Variation Request

Modification 0501 – Treatment of Existing Entry Capacity Rights at the Bacton ASEP to comply with EU Capacity Regulations

Date: 22 April 2015

Timeline for Bacton Reallocation Process

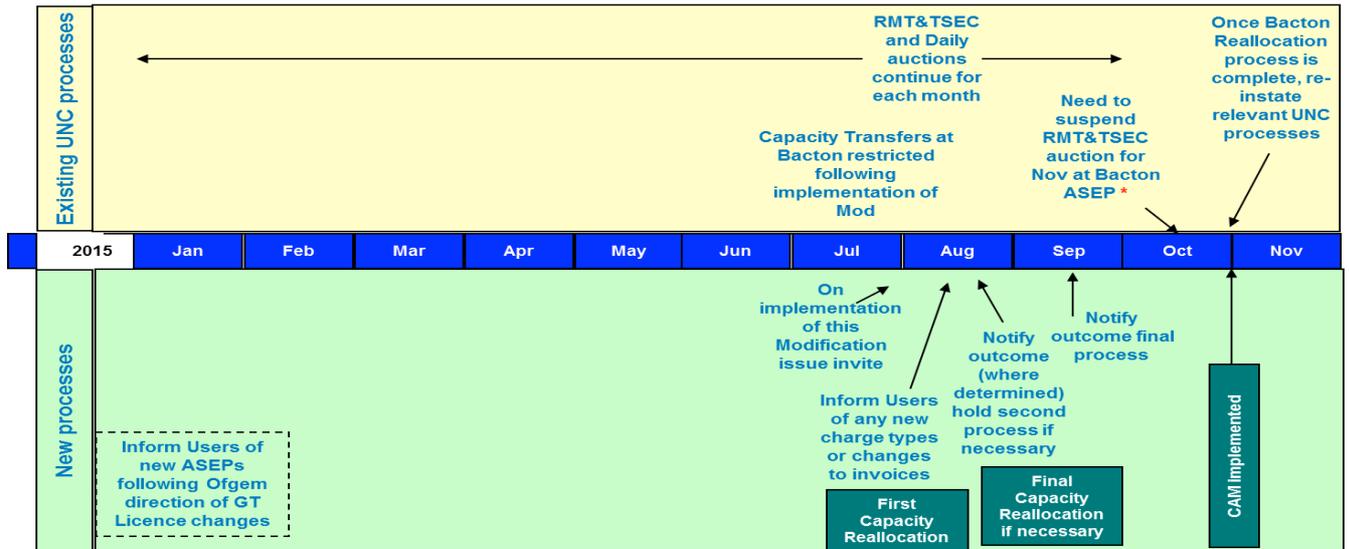
The existing timeline diagram in Section 3 should be deleted and replaced with:

* The day ahead auction for Bacton UKCS and Bacton IP will commence on the 31st October 2015
